SERVICE BULLETIN #1120

SUBJECT: WRONG WOODRUFF KEY IN PARTS ENVELOPE

MODEL 1-61, 1-81, 1-81HD DATE 1/25/61

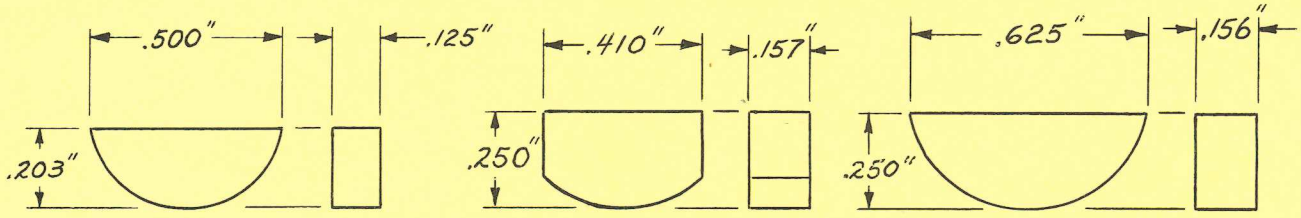
Some Model 1-61, 1-81 and 1-81HD engines were shipped from the factory with Woodruff key, P/N 100199, in the parts envelope for use in installing the sprocket. Woodruff key, P/N 100199 is too narrow and will be a loose fit in the sprocket and sprocket shaft. The play between the key, sprocket and shaft that results from this loose fit can damage the sprocket and sprocket shaft. The Engine Models and the range of serial numbers affected that may have this narrow key in the parts envelope are listed below:

Do not use the narrow Woodruff key, P/N 100199, under the sprocket of any of the above engines. It must be replaced with the correct Woodruff key or the sprocket and sprocket shaft may be seriously damaged.

To help you to determine if the Woodruff key packed in the envelope is the correct one, compare with the keys in the illustration below.

P/N 100199 - (Wrong) -

The Woodruff key that should be in the parts envelope can be either, P/N 55953, or, P/N 100256. If you have any engines of the Model and serial number listed above, examine the Woodruff key in the parts envelope to make sure it is the correct one to fit the sprocket and shaft.

Note: Latest engineering changes have declared Woodruff key, P/N 55953, is to be used on future production of the above engines. If you do not have the correct key, order it by Part Number 55953.

P/N 55953

P/N 100256
